FINAL ENVIRONMENTAL IMPACT REPORT
DECIMA ALLEN ELEMENTARY SCHOOL REPLACEMENT
PROJECT
SCH#: 2020039043

December 2020

**FINAL ENVIRONMENTAL IMPACT REPORT:
DECIMA ALLEN ELEMENTARY SCHOOL REPLACEMENT PROJECT**

Figure 2 Proposed Decima Allen Elementary School Plan – Source: HY Architects
Decima Allen Elementary School Traffic and Parking Study – San Bruno

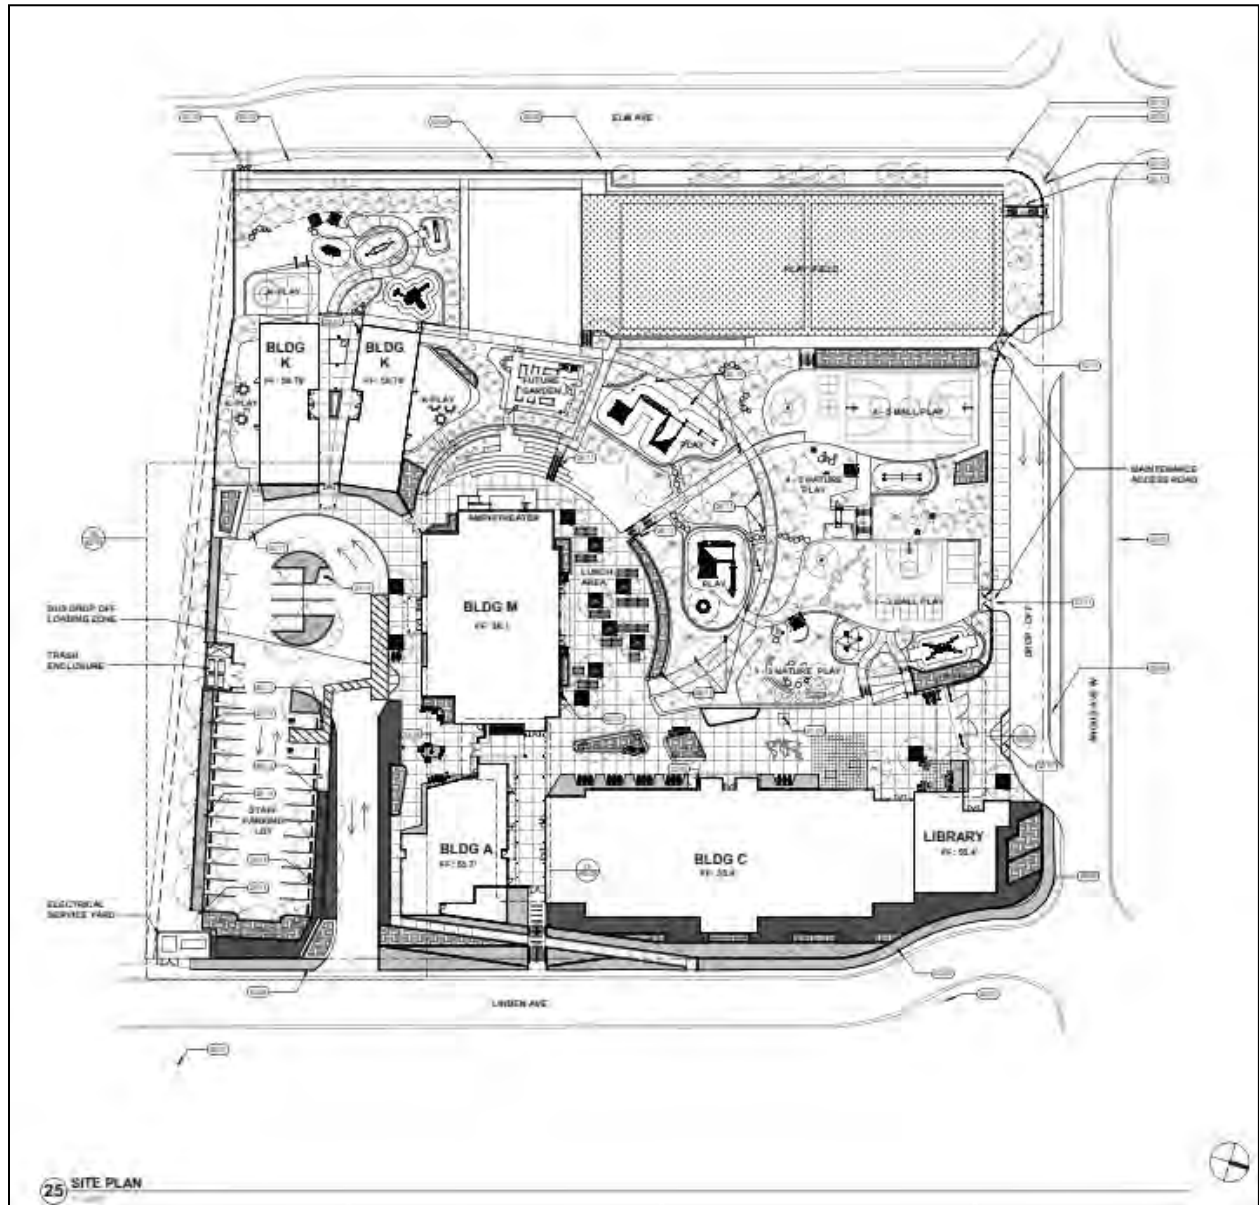
- ⑥ | ○ Figure 2 shows a "Drop Off" label within the staff parking lot. This label conflicts with Section 4.5 of the report where it states that no drop-offs will take place in the staff parking lot. Please clarify.

6. The project site plan (Figure 2) in the traffic report has been revised. All student drop-off and pick up will occur at the new internal drop-off area at W. Angus Avenue. No drop-off/pick up will be permitted at the staff parking area. A revised site plan without drop-off label has been incorporated in the revised traffic report.

Figure 4 Current (2019) Intersection Peak Hour Traffic Volumes - am vol. (pm vol.)
 Decima Allen Elementary School Traffic and Parking Study – San Bruno

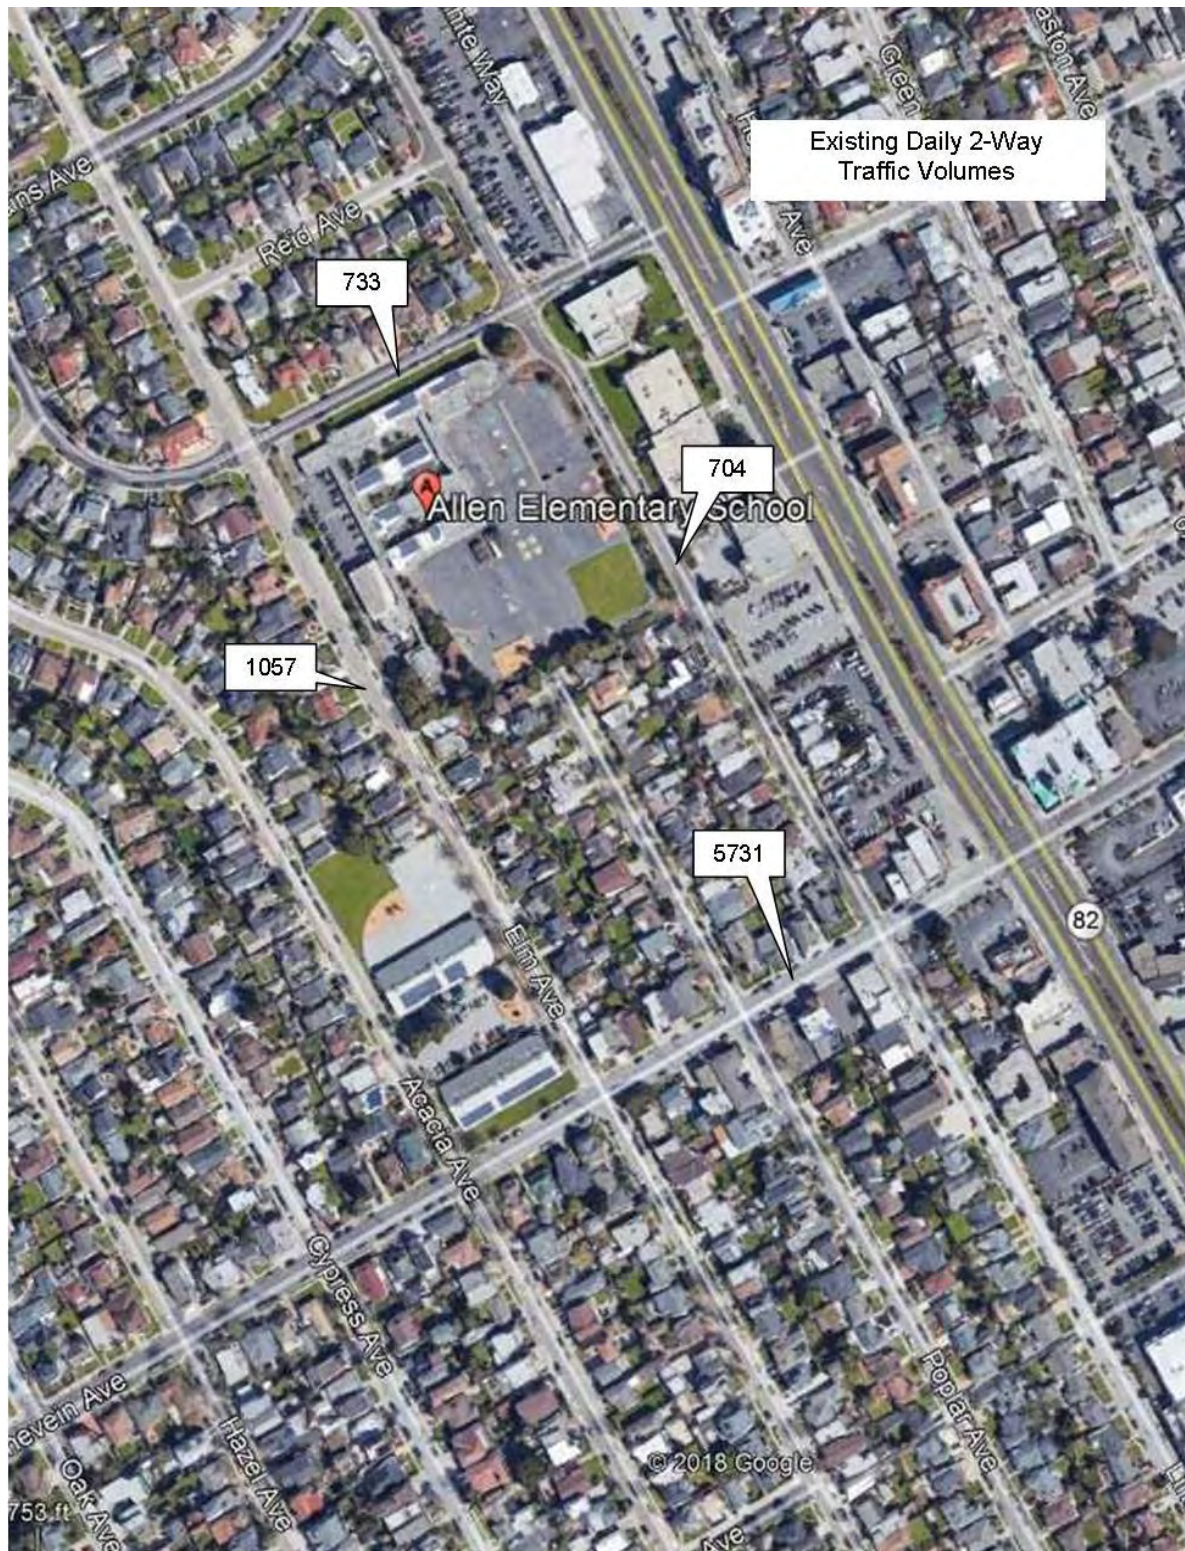
- ⑨ | ○ Revise description of the City's LOS standard. Please review and apply to section 3.1.
 - ⑩ | ○ Figures 4, 7, 10 have mislabeled figures at the Jenevein Avenue and Linden Avenue intersection.

10. The street names Jenevein Avenue and Linden Avenue for Figures 4, 7, and 10 have been corrected. Please see revised traffic report.

Figure 9 Study Area Parking Saturation Analysis
Allen Elementary School Traffic and Traffic Analysis

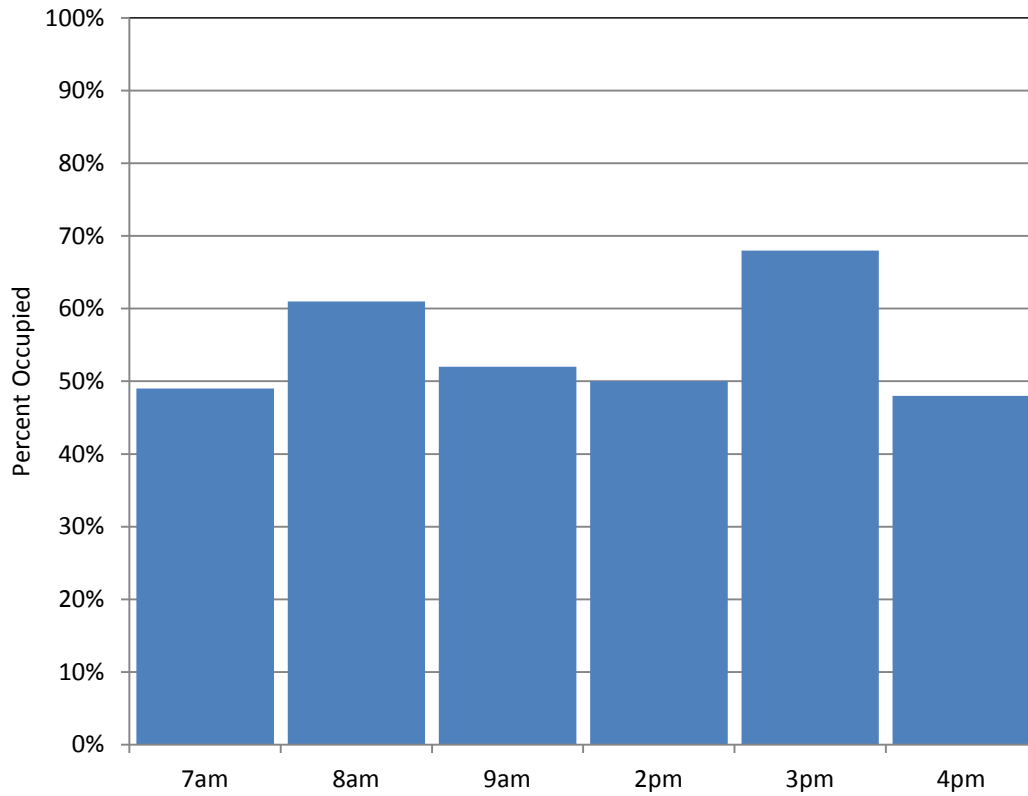
- (18) | • In reference to the Parking Study, off-site/on-street parking should not be included in the parking analysis required by a development.
- (19) | • In reference to Table 9 (page 26) and Figure 9 (Page 28), it has been assumed that the parking capacity is 100% of theoretical capacity. In practice when parking capacity reaches 85% of theoretical capacity, it is considered full. Table 9 and Figure 9 and related text should be revised and available parking should be re-calculate such that parking capacity should be equal to theoretical capacity multiplied by 0.85.
